# RHA - NOTES FROM THE FIELD

## CIVIL AND SITE COORDINATION

JULIETTE BALCONY DETAIL

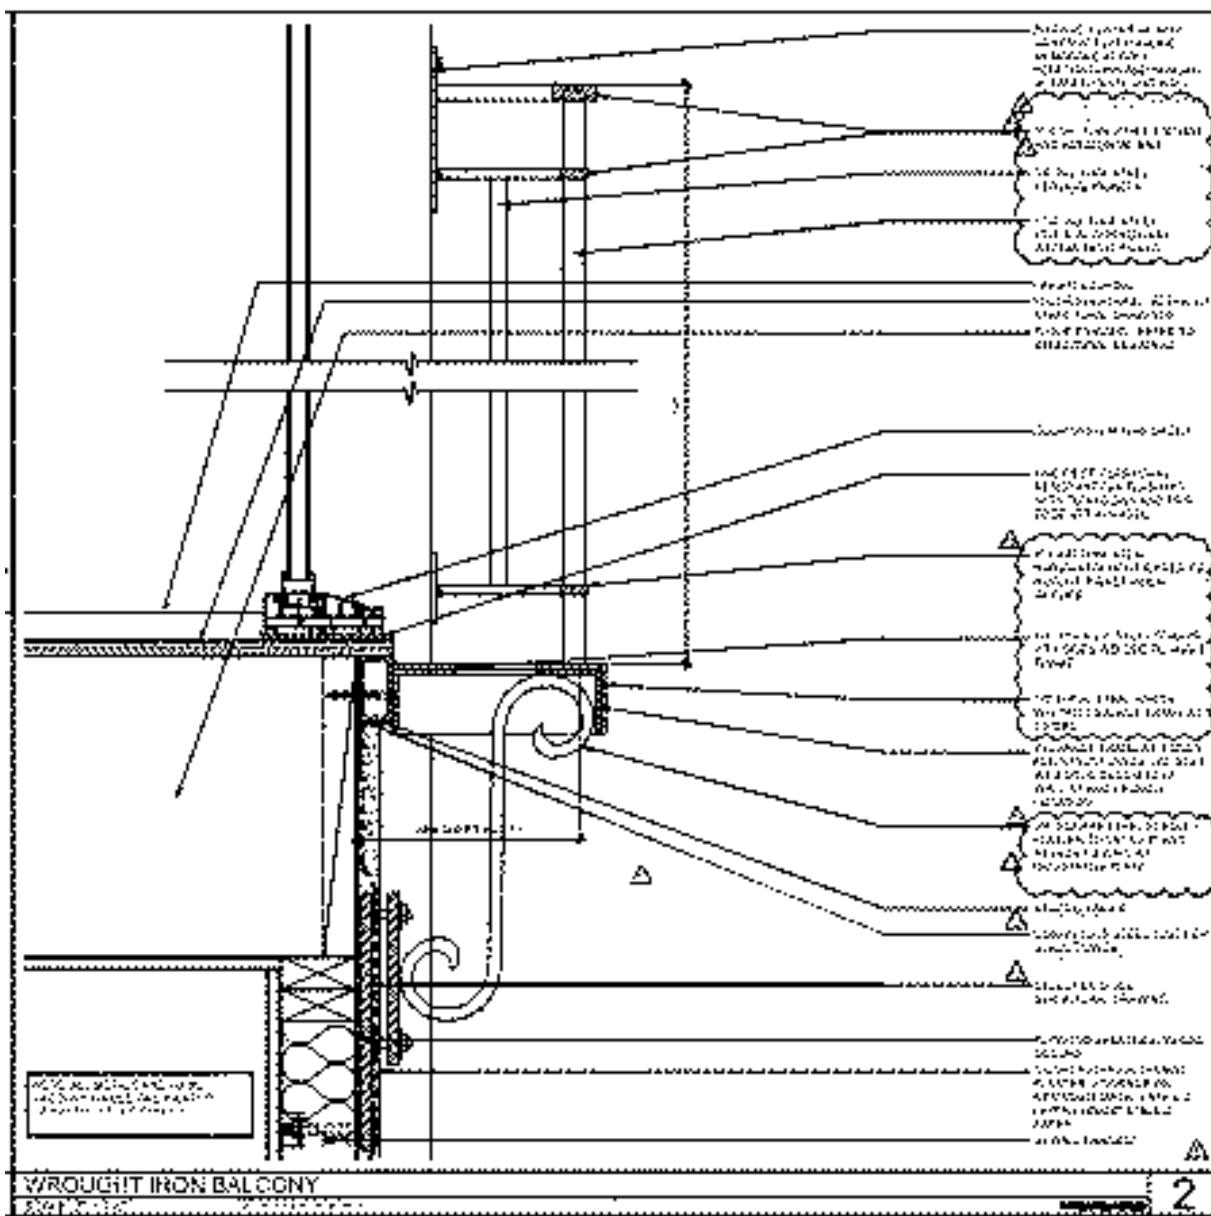
TAKE-AWAY: Coordinate balcony detail conditions with drainage slopes.  
Consider accessibility requirements for "changes in floor level" - CBC Chapter 11A

FLOOR PLAN

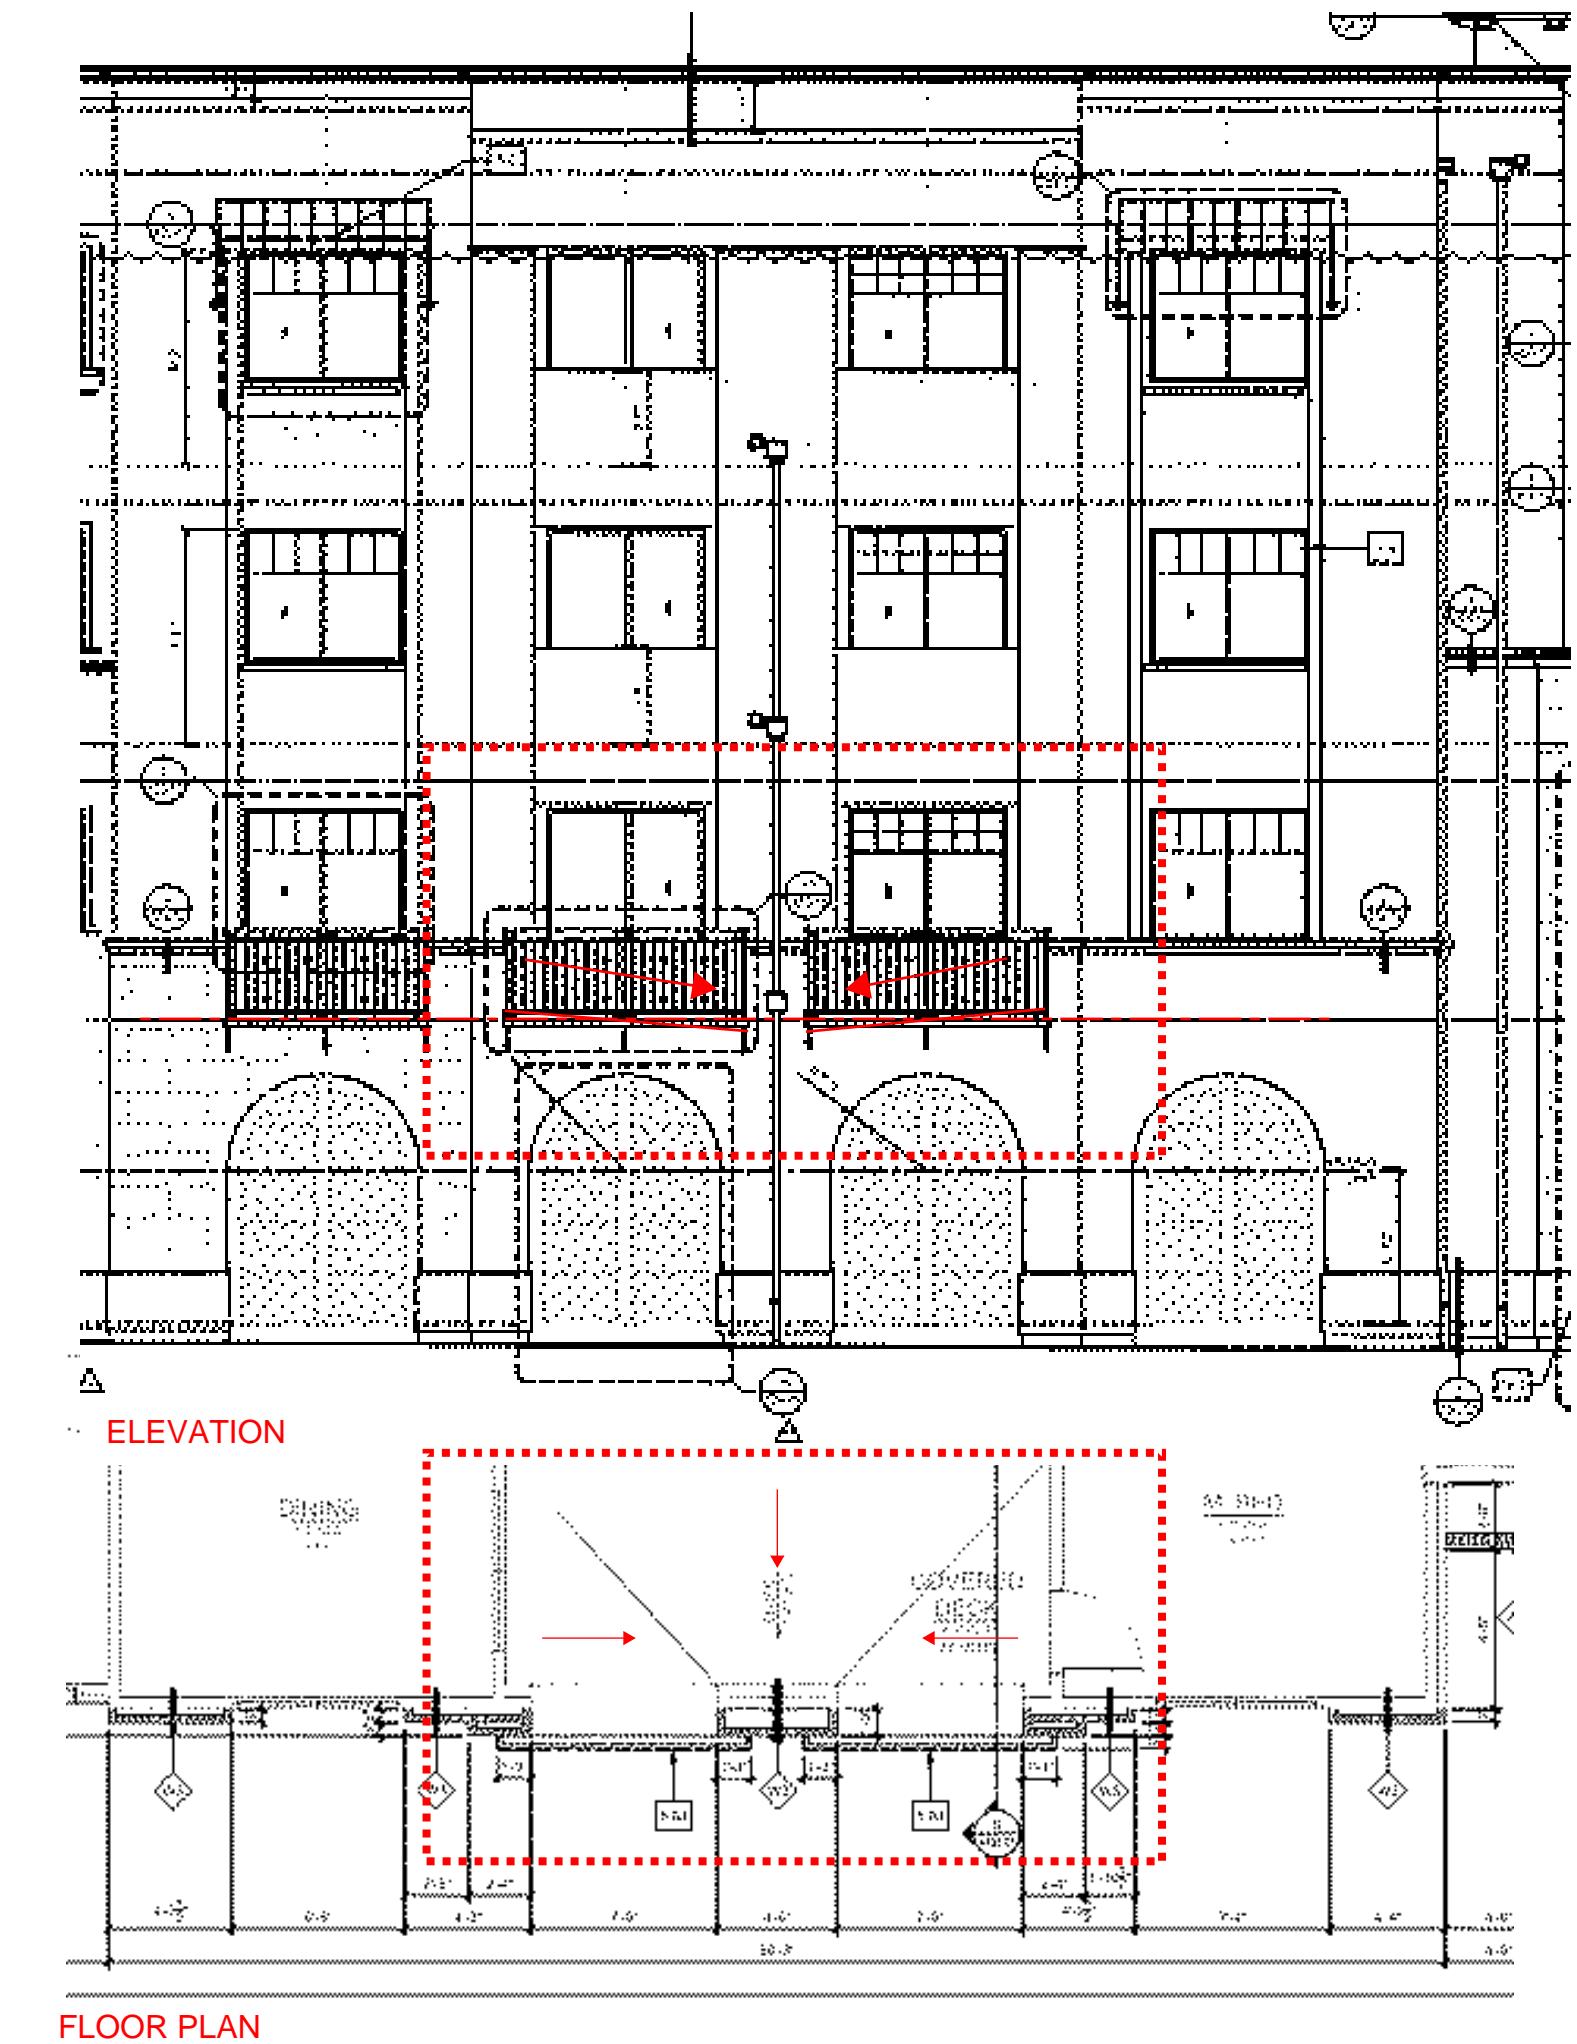
TAKE-AWAY: Coordinate structural framing plans with architectural plans. The expectation is that the Architect is the "quarterback".
